SUBJECT: POINT BEACH NUCLEAR PLANT, UNITS 1 AND 2 - ISSUANCE OF
AMENDMENTS RE: DESIGN AND OPERATION OF FUEL CYCLES WITH
UPGRADED WESTINGHOUSE FUEL (TAC NOS. MA5939 AND MA5940)

The Commission has issued the enclosed Amendment No. 193 to Facility Operating License No. DPR-24 and Amendment No. 198 to Facility Operating License No. DPR-27 for the Point Beach Nuclear Plant, Units 1 and 2, respectively. The amendments revise the Technical Specifications (TSs) in response to your application dated June 22, 1999, as supplemented December 17, 1999.

These amendments reflect changes to the TSs related to the design and operation of the Point Beach fuel cycle in order to incorporate the Westinghouse 422V+ fuel assemblies into reactor cores.

ATTACHMENT TO LICENSE AMENDMENT NO. 193

Figure 15.2.1-1*
 POINT BEACH NUCLEAR PLANT UNITS 1 AND 2
 REACTOR CORE SAFETY LIMITS

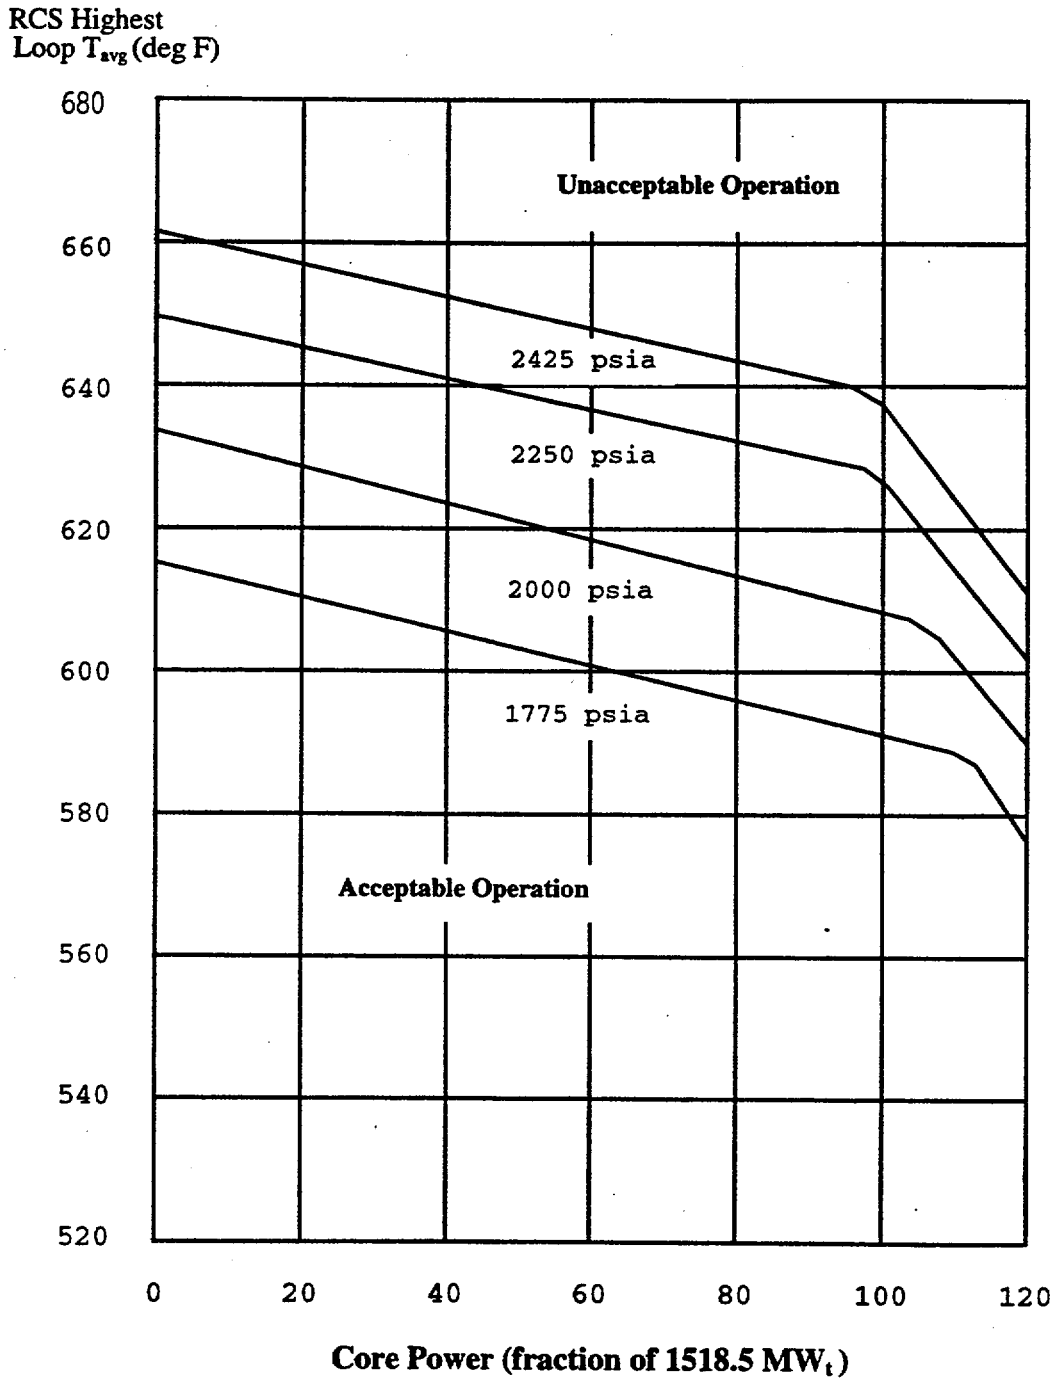
The family of curves in Figure 15.2.1-1 is applicable to a core with any combination of 14 x 14 OFA and 14 x 14 upgraded OFA fuel assemblies. The family of curves in Figure 15.2.1-2 is applicable to any combination of 422V+ fuel assemblies, burned 14 x 14 OFA fuel assemblies, and burned 14 x 14 Upgraded OFA fuel assemblies, or a full core of 422V+ fuel assemblies. The use of these assemblies is justified by a cycle-specific reload analysis. The WRB-1 correlation is used to generate these curves. Uncertainties in plant parameters and DNB correlation predictions are statistically convoluted to obtain a DNBR uncertainty factor. This DNBR uncertainty factor establishes a value of design limit DNBR. This value of design limit DNBR is shown to be met in plant safety analyses, using values of input parameters considered at their nominal values.

* This figure applies to core reloads with any combination of OFA and Upgraded OFA fuel assemblies.

Figure 15.2.1-2*
POINT BEACH NUCLEAR PLANT UNITS 1 AND 2
REACTOR CORE SAFETY LIMITS

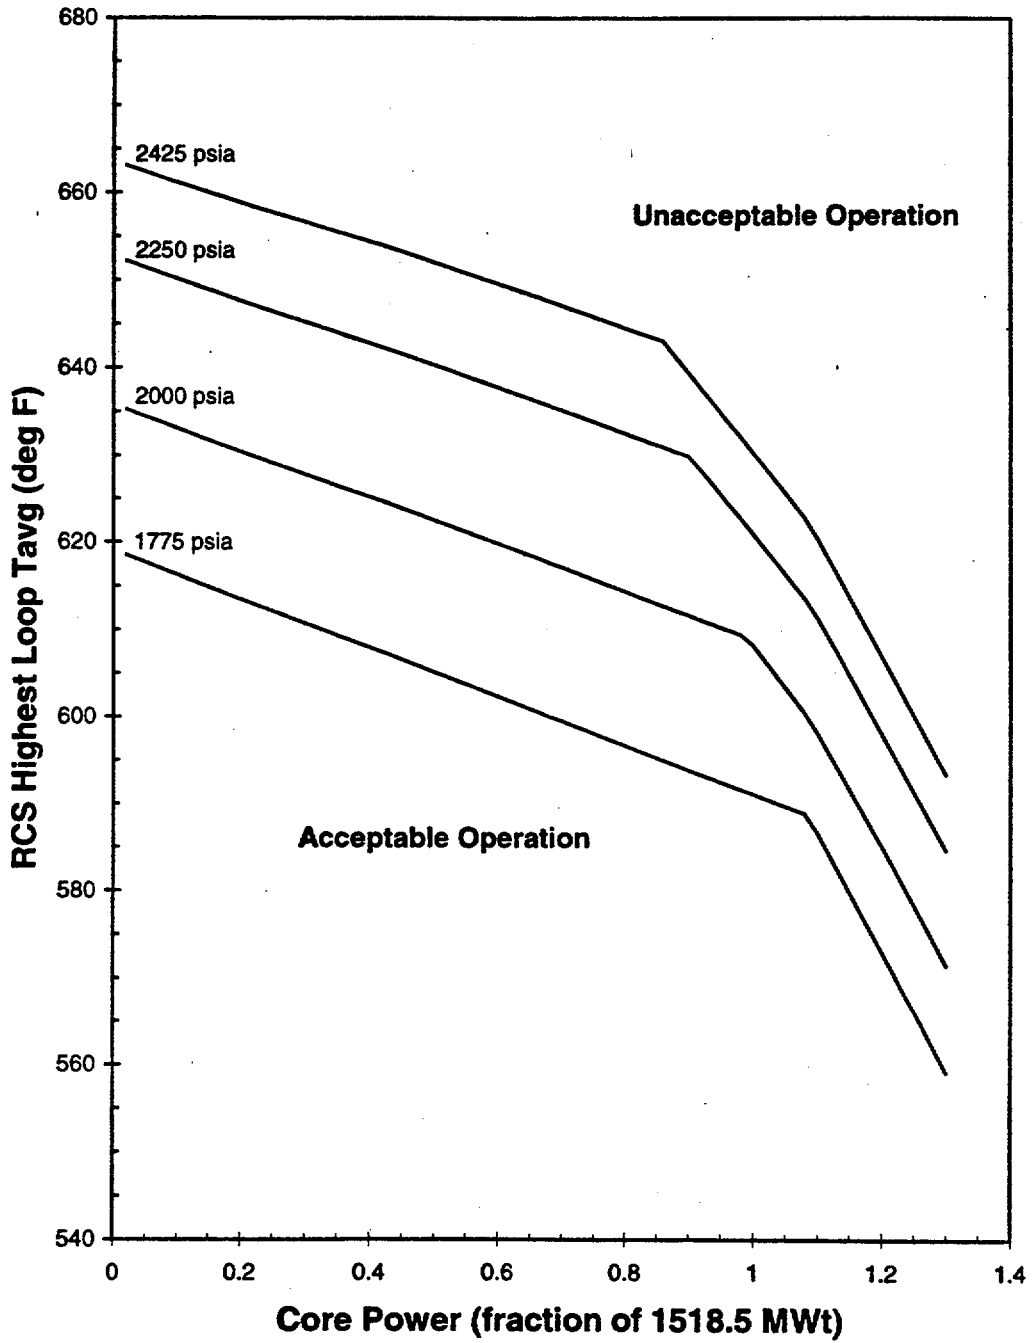
* This figure applies to core reloads with any combination of 422V+ fuel assemblies, burned OFA and burned Upgraded OFA fuel assemblies, or a full core of 422V+ fuel assemblies.

The overpower, overtemperature and pressurizer pressure system setpoints for OFA and Upgraded OFA fuel include the effect of reduced system pressure operation (including the effects of fuel densification). The setpoints for 422V+ fuel do not include the effect of reduced system pressure operation; therefore, cores containing 422V+ fuel must be operated at 2250 psia. The setpoints will not exceed the core safety limits as shown in Figures 15.2.1-1 (for OFA and Upgraded OFA fuel only cores) and 15.2.1-2 (for cores containing 422V+ fuel).

FIGURE 15.3.10-3

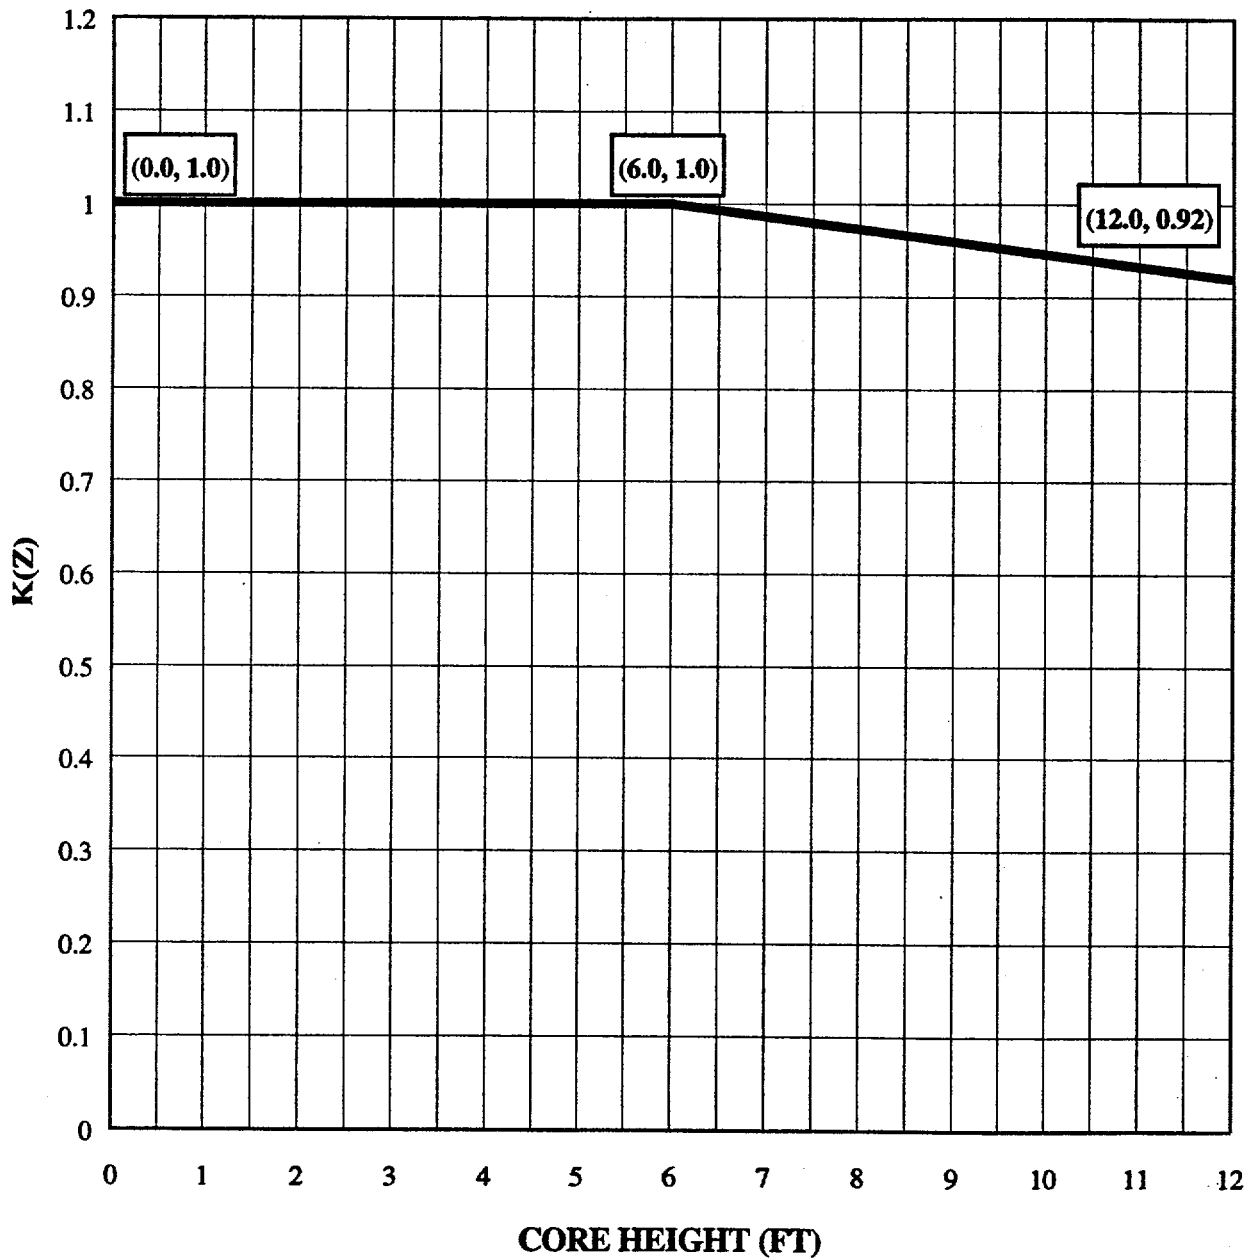
As a result of the increased peaking factors allowed by the new 422V+ fuel, a new column was added to TS 15.3.10.E.1.a. The full power $F_{\Delta H}^N$ peaking factor design limit (radial peaking factor) for 422V+ fuel will increase to 1.77 from the 1.70 value for the OFA fuel. The maximum $F_Q(Z)$ peaking factor limit (total peaking factor) for 422V+ fuel will increase to 2.60 from the 2.50 value for the OFA fuel. The OFA fuel design will retain the current $F_{\Delta H}^N$ and $F_Q(Z)$ peaking factors of 1.70 and 2.50, respectively. In addition, the $K(Z)$ envelope for the new 422V+ fuel was modified and a new TS figure 15.3.10-3a was developed and inserted in the Technical Specifications. The $K(Z)$ envelope in TS Figure 15.3.10-3 remains for the OFA fuel.

The upper bound envelope F_Q (defined in 15.3.10.E) times the normalized peaking factor axial dependence of Figure 15.3.10-3 for OFA and Upgraded OFA fuel and Figure 15.3.10.3a for 422V+ fuel (consistent with the Technical Specifications on power distribution control as given in Section 15.3.10) was used in the large and small break LOCA analyses. The envelope was determined based on allowable power density distributions at full power restricted to axial flux difference (ΔI) values consistent with those in Specification 15.3.10.E.2.

FIGURE 15.3.10-3A

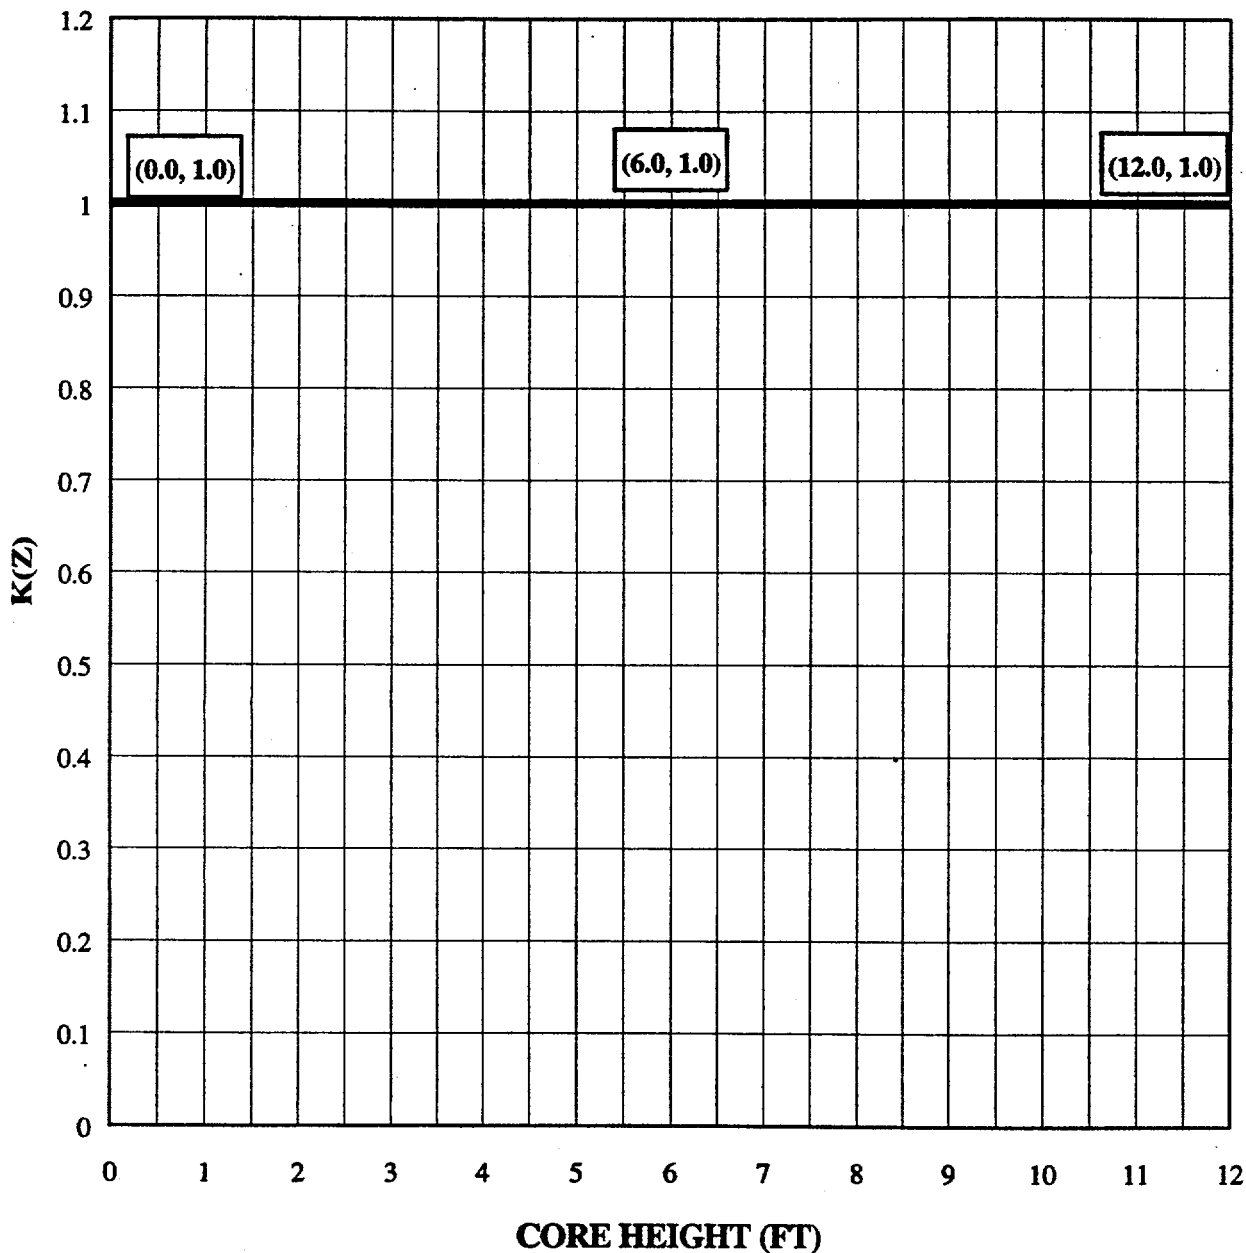
Where P is the fraction of full power at which the core is operating, K(Z) is the function in Figure 15.3.10-3 or Figure 15.3.10-3a, as applicable, and Z is the core height location of F_Q .
